ADDENDUM NO. 1
March 4, 2024

FIRE STATION # 1
City of Marion
Marion, AR 72364

The following changes, clarifications, additions or deletions shall be made a part of the Contract Documents.

A1.2

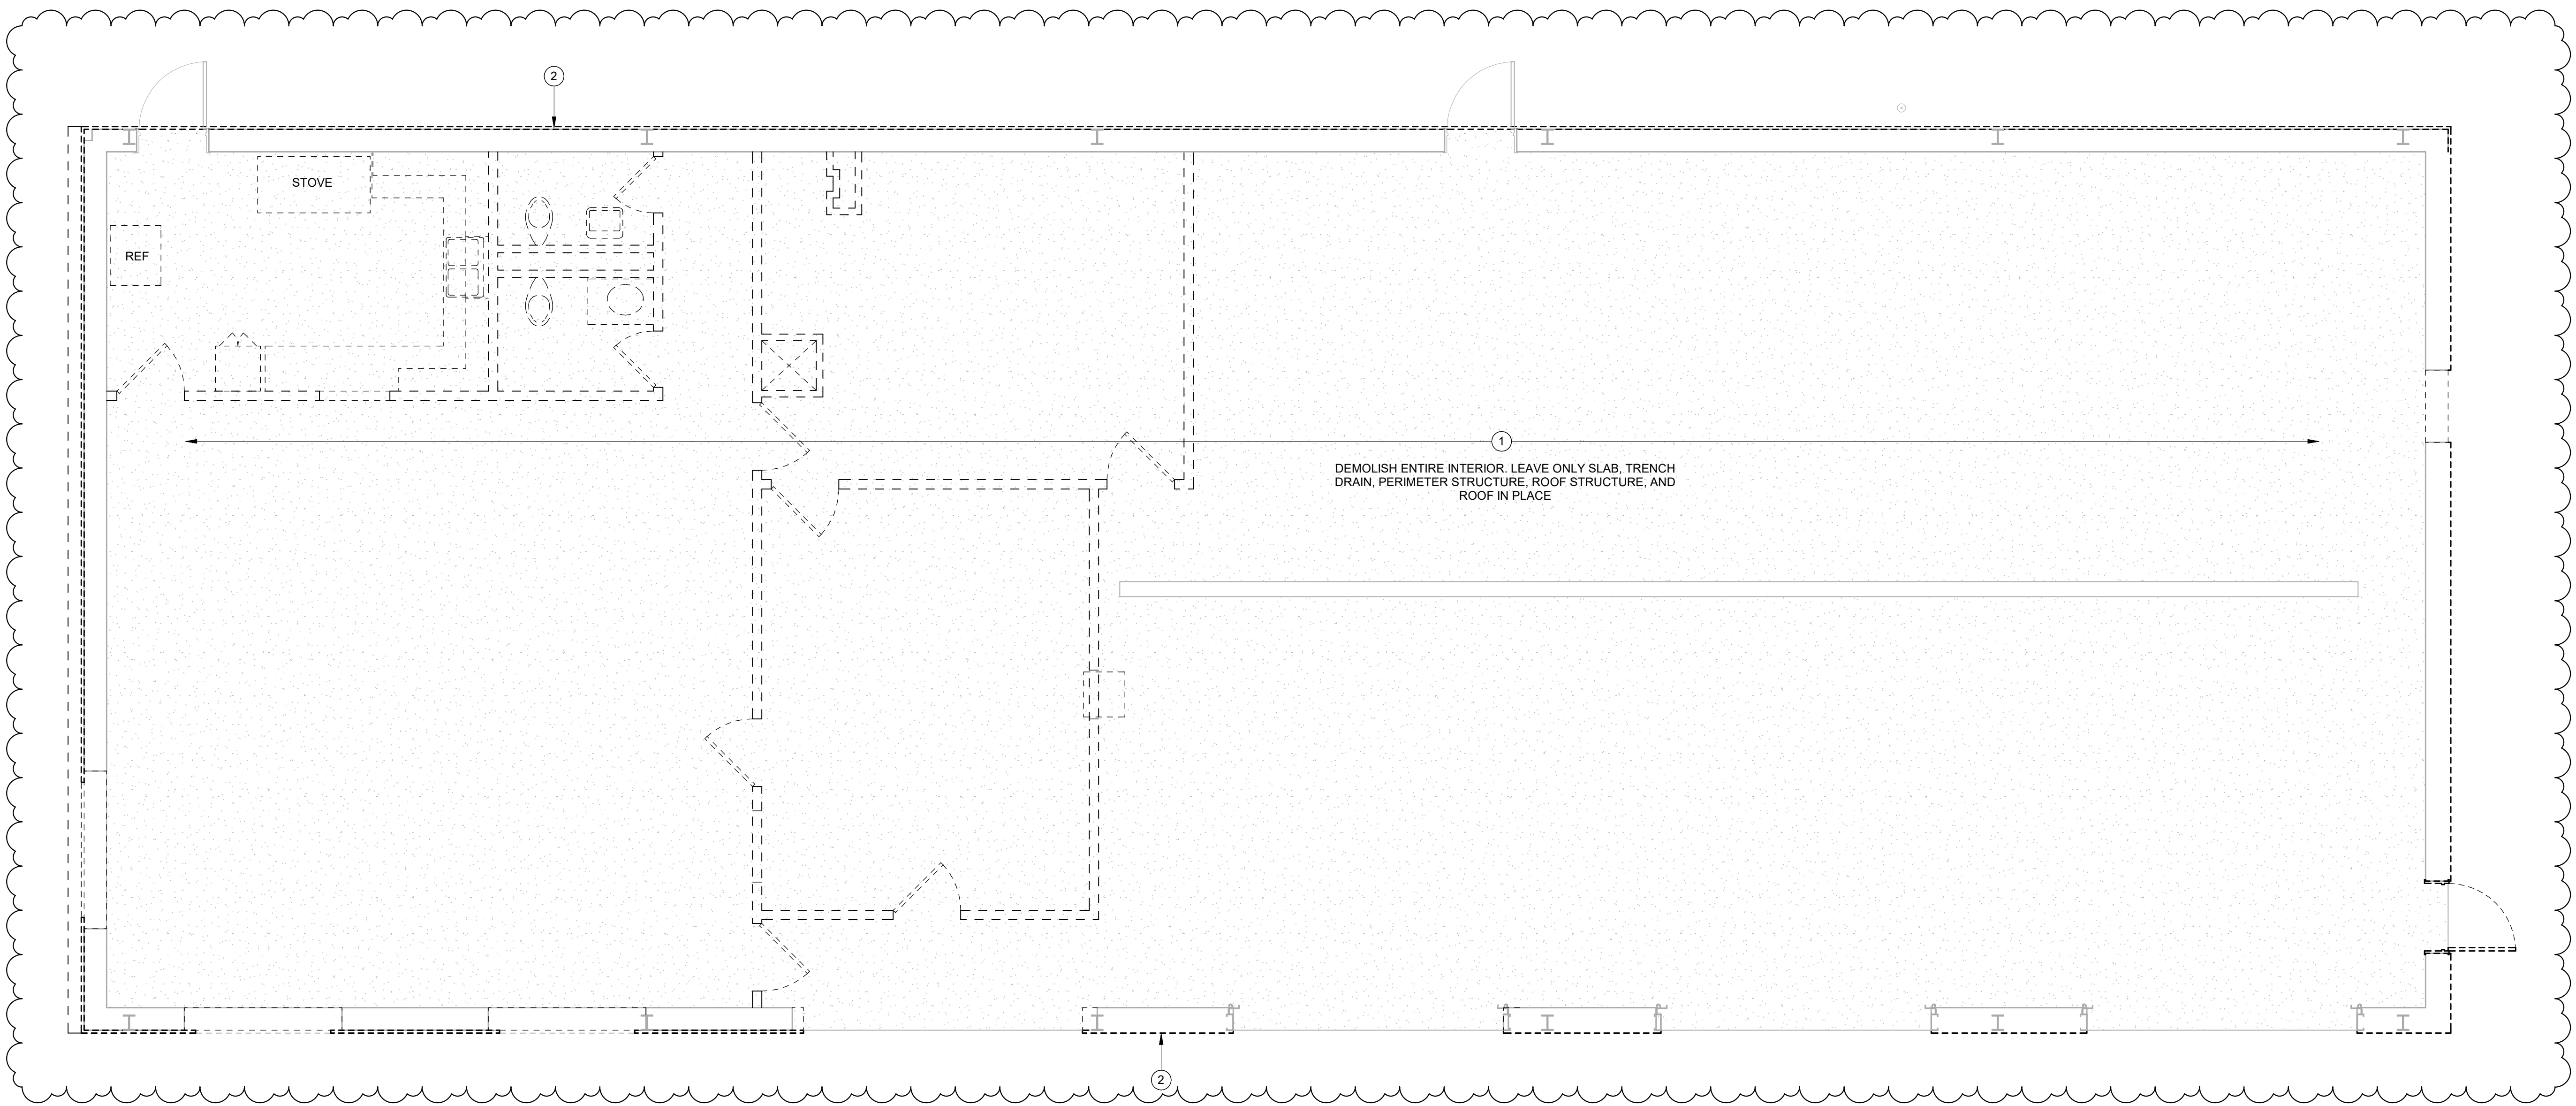
A1.2 Added demolition information for clarification.

A2.1

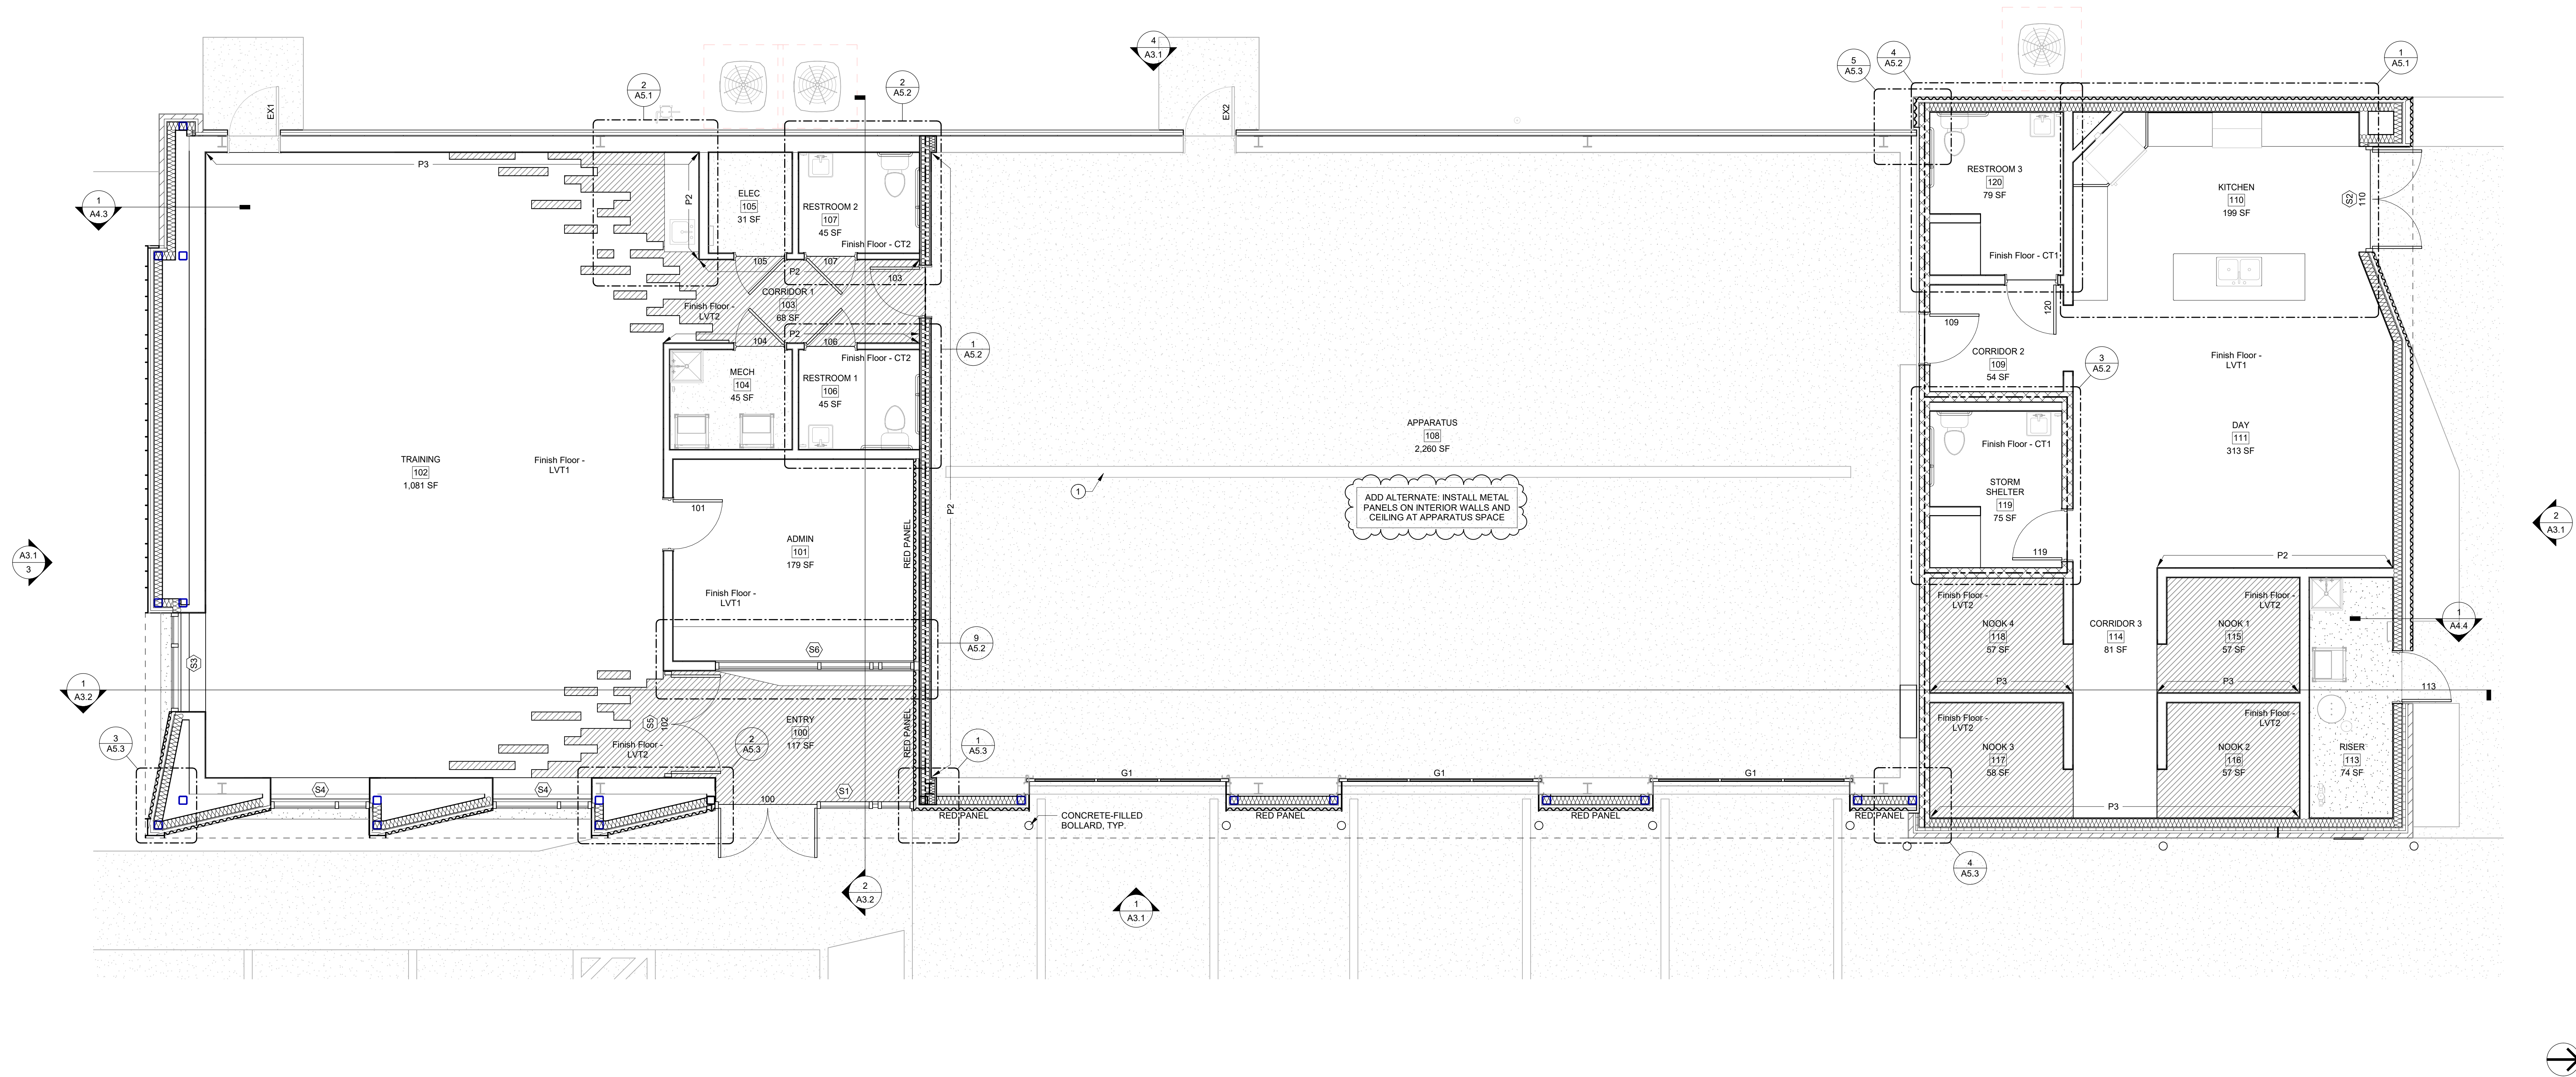
A2.1 Revised "Add Alternate" Note. Revised Keynote "1" for drain cover clarification.

A2.2

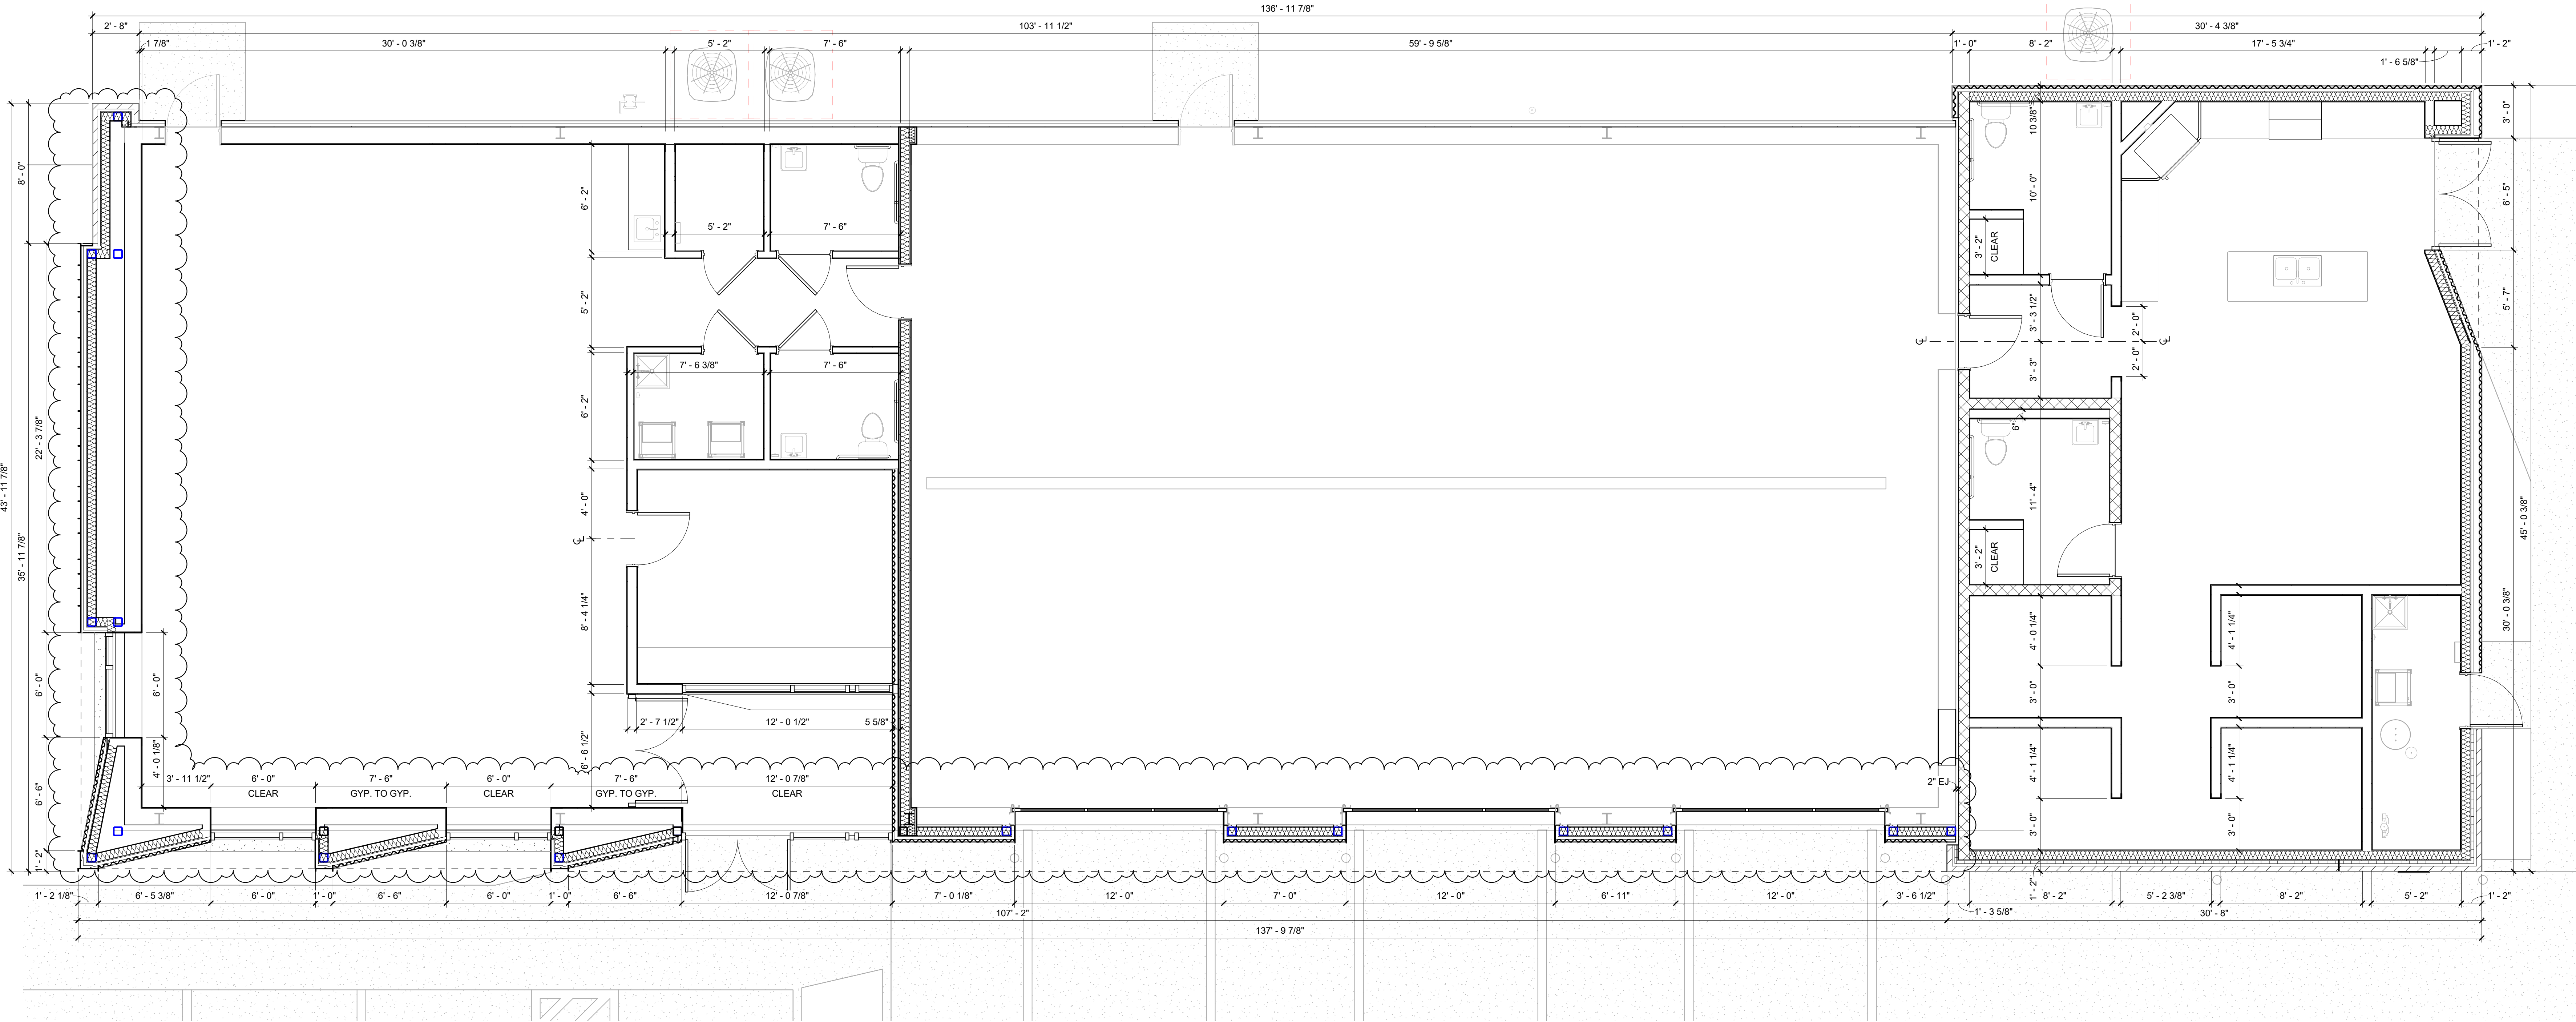
A2.2 Revised structural column locations per updated Structural Plan (sheet S2.1).

A2.3

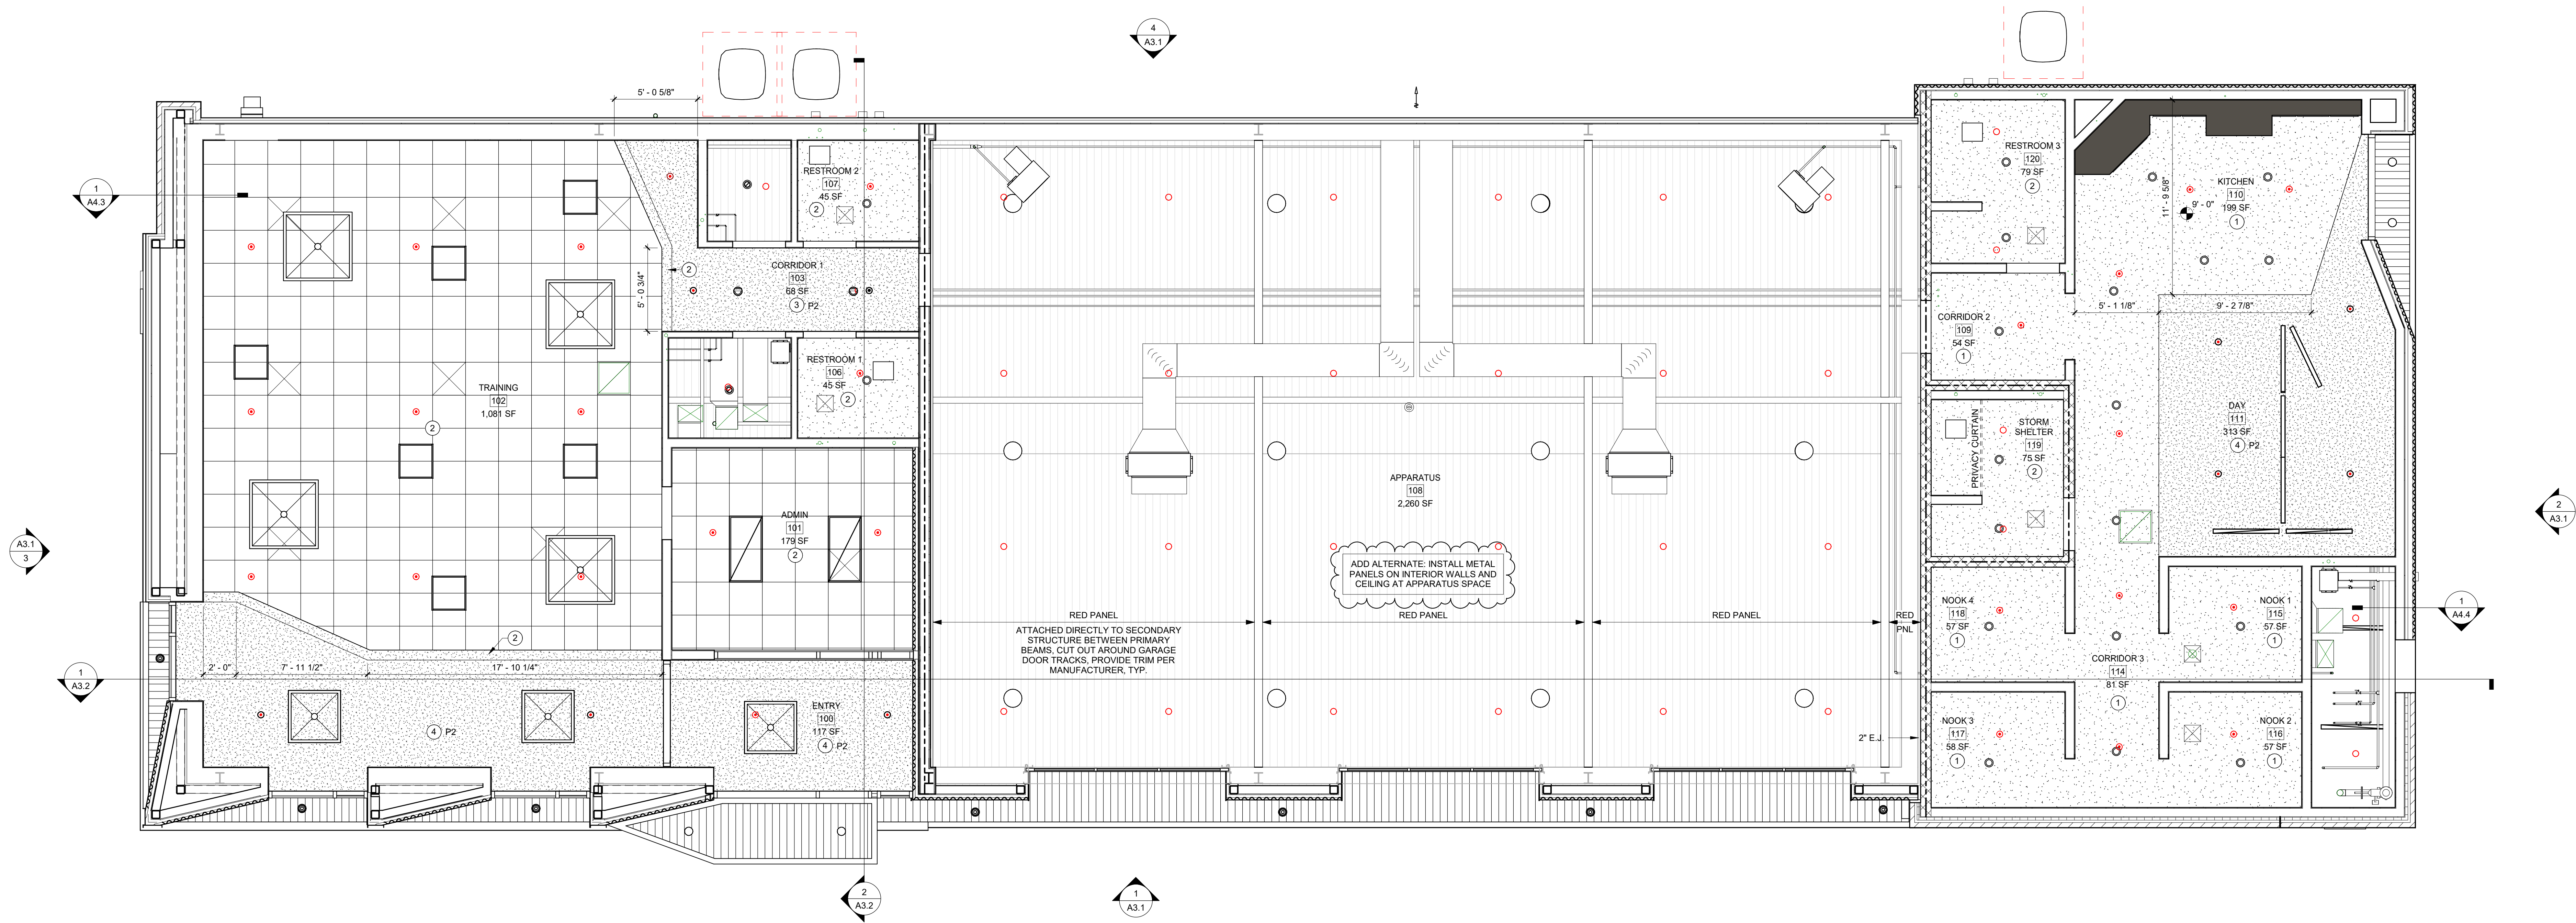
A2.3 Added "Add Alternate" Note for clarification.
